## **SLAT SECTION 3 — INSPECTION/CHECK**

\*\*\*Paras 2, 3C, 4B(1), 4B(6): CORRECTION/ADDITION/AMPLIFICATION

## TASK 57-44-00-220-802

## **Detailed Inspection of the Slat Section 3 Tracks 6 and 7**

Measuring of the track wear Figure 602

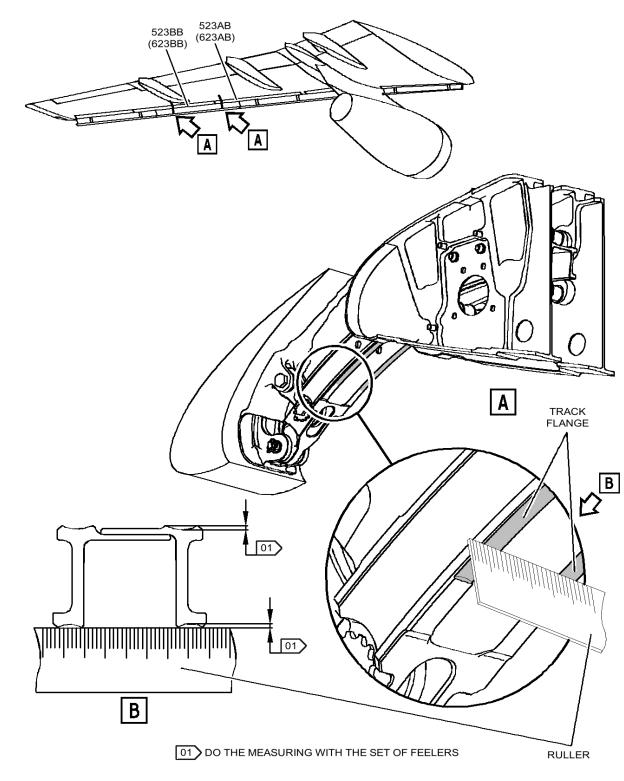
\*\*\*Figure 602: CHANGED

Permitted wear of the working surfaces of the track flanges under the bearing and support rollers in the form of the smooth groove is not more than 0.2 mm (0.008 in). Permitted wear of the working surfaces of the tracks under the bearing and support rollers in the places. which correspond to the extended and retracted position of the slat, is not more than 0.3 mm (0.01 in).

Do the measurement with the set of feelers 0.05 mm (0.002 in) – 0.3 mm (0.01 in) and the metalic ruller [lenght is not more then 100 mm (3.93 in)] on the upper and lower track flanges. Measure the gap between the edge of the metal ruler and the wear on the track surface.

Measure the gaps only in the front part of the track in about 20 mm (0.78 in) distance from the contact point of the front lower support rollers Apply a ruler across the working surface of the track perpendicular to its surface (ref. Fig. 602).
